IREDELL COUNTY HEALTH DEPARTMENT

IMPROVEMENT PERMIT / AUTHORIZATION TO CONSTRUCT / OPERATION PERMIT / EXISTING SYSTEM INSPECTION

PERMIT# 116647 PIN# 4710-66-5364 DATE 8-4-05

SUBDIVISION SPRING STONE BLOCK / SECTION LOT 30 LOT AREA 1.00AC SITE CLASS. PS DESIGN FLOW 240 L.T.A.R. 135

INITIAL SITE SKETCH 1" = 60'

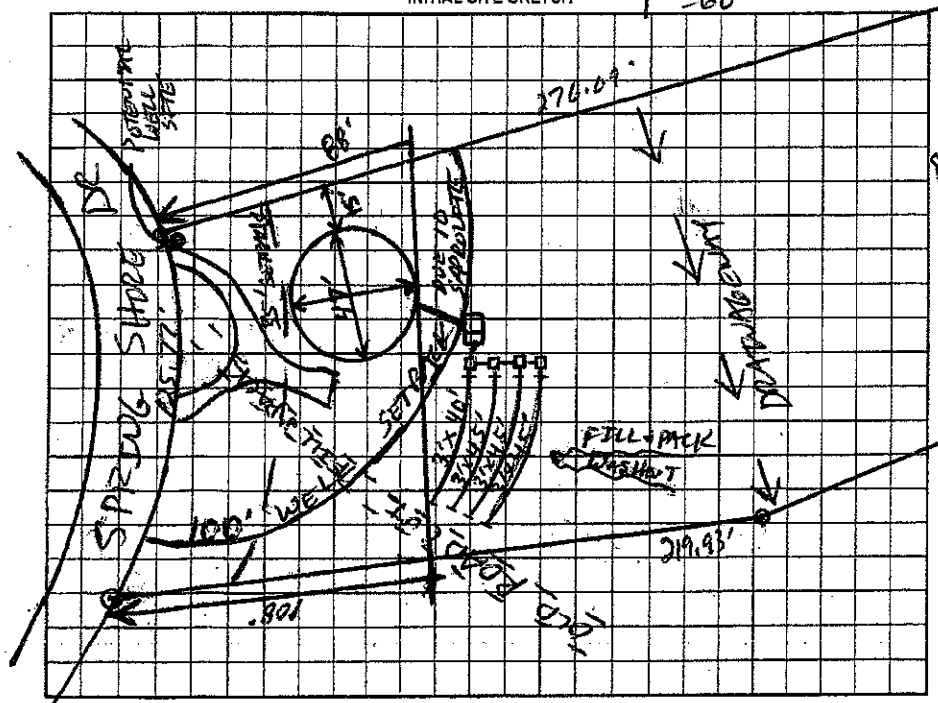
Comments/Conditions: ① DECK EXTENDS 5' OFF HOUSE. IT IS CANTILEVER SO 5' SETBACK IS OFF HOUSE & NOT DECK. ② DIVERT SURFACE H2O AWAY FROM SYSTEM & FILL & PACK OLD ROAD BED. THIS WILL help Stabilize the hill

Comments/Conditions: due to 28% SLOPE. ③ F:U & PACK LOWER WAS NOT ④ MAINTAIN SETBACKS ⑤ THIS IS A SAPROLITE SYSTEM ⑥ THIS IS A REDRAW DUE TO COMM. WELL NOT BEING AVAILABLE

AS BUILT SKETCH

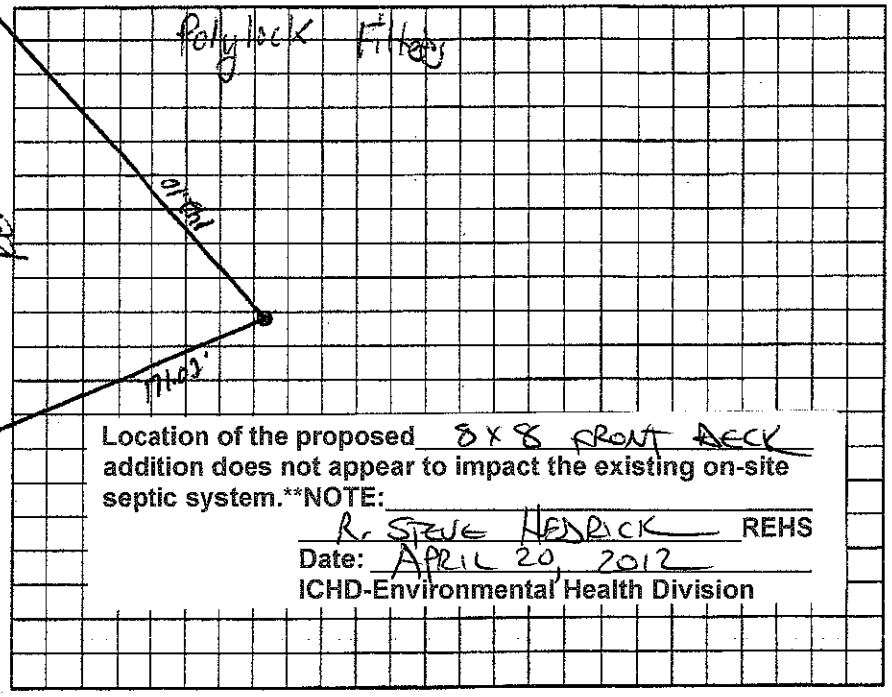
Location of the proposed 8 X 8 FRONT DECK addition does not appear to impact the existing on-site septic system.**NOTE:
